EPC STORMWATER REVIEW COMMENTS
IN ORANGE BOXES WITH BLACK TEXT

# MERIDIAN STORAGE

## CONSTRUCTION DRAWINGS

~~SF-23-XXX~~ Add PCD File #VR239

TYPICAL STREET SECTION – URBAN LOCAL ROADWAY
N.T.S.

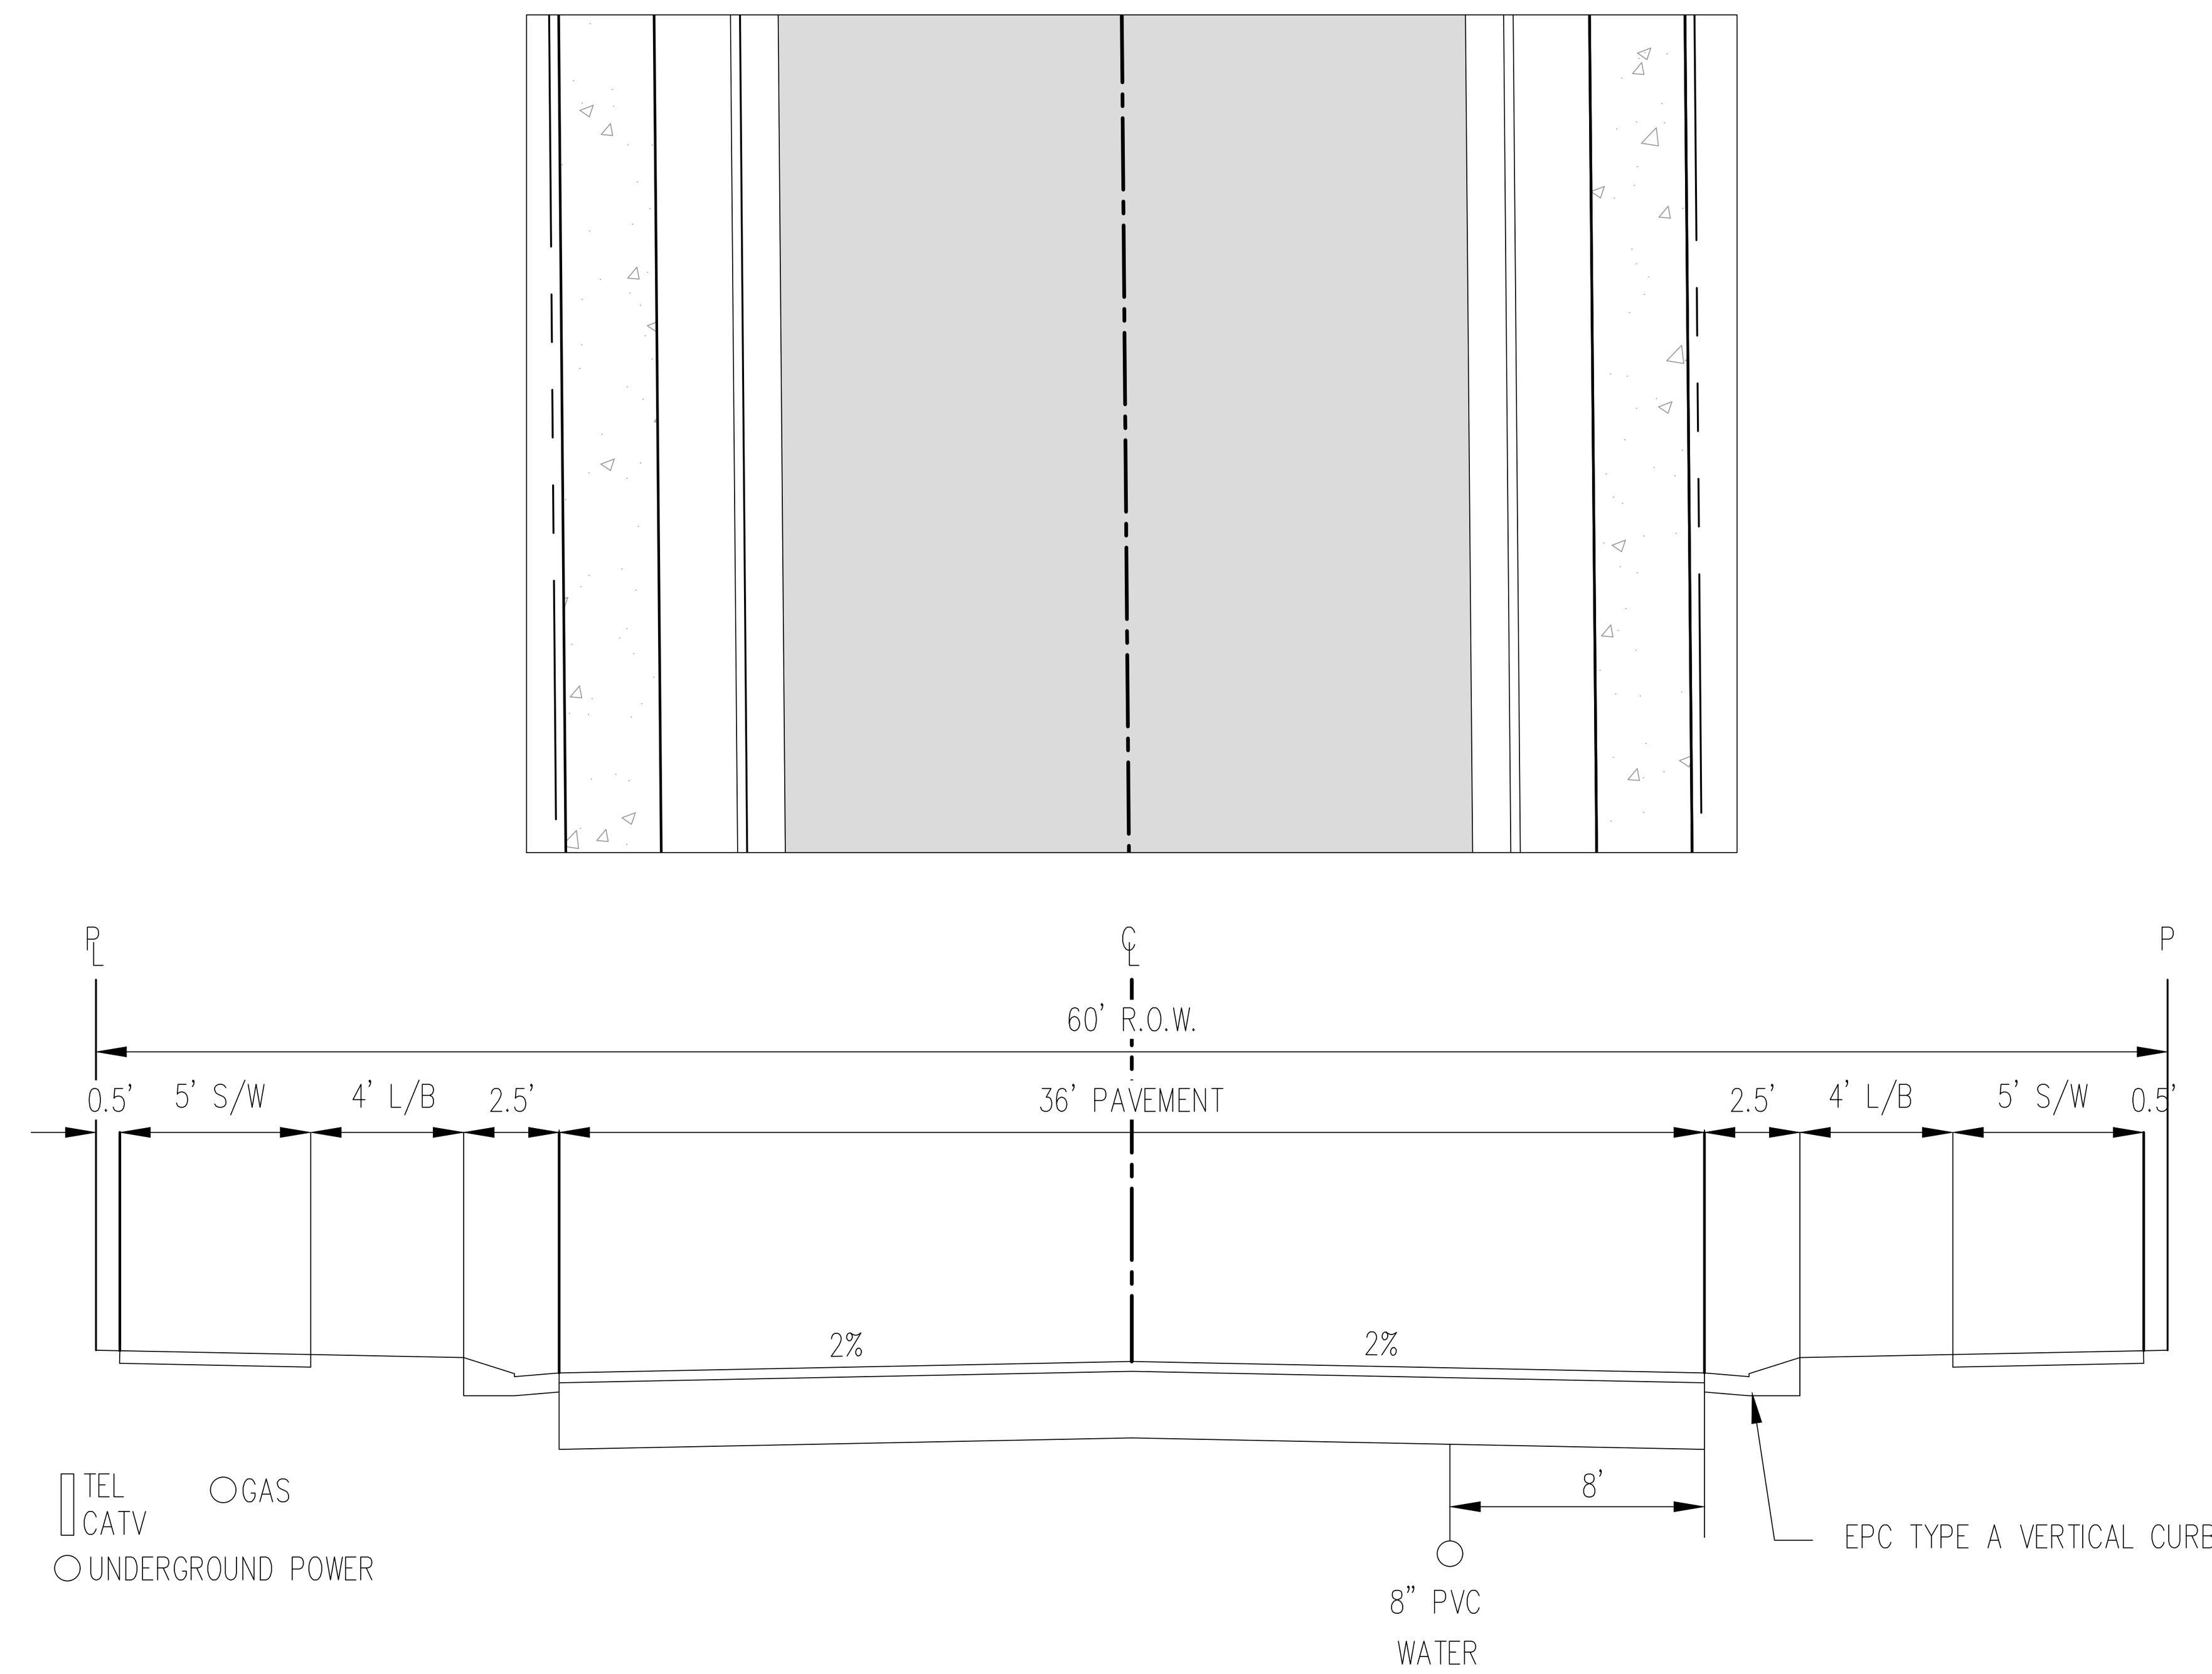
Add design and posted speed note 25/25mph

STORM DRAIN PLAN – LINE C

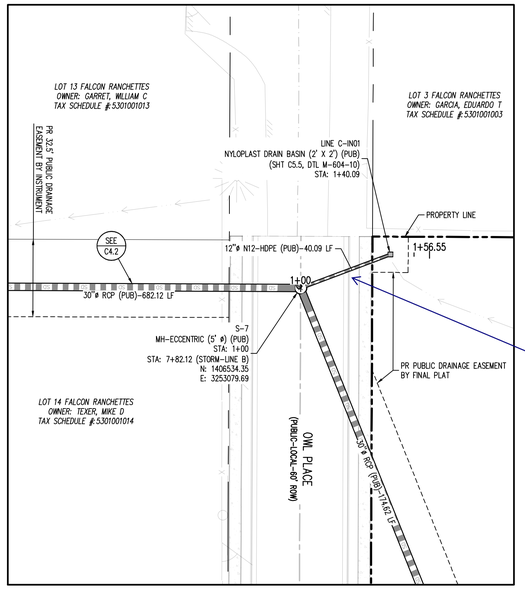
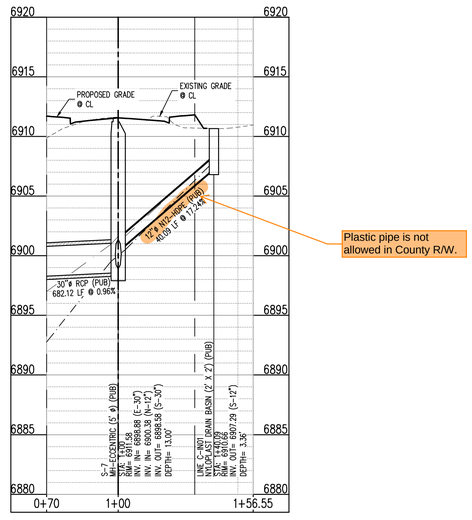
all storm sewers within the County's ROW are required to be RCP and a min. 18". See ECM 3.3.1.J.

Plastic pipe is not allowed in County R/W.
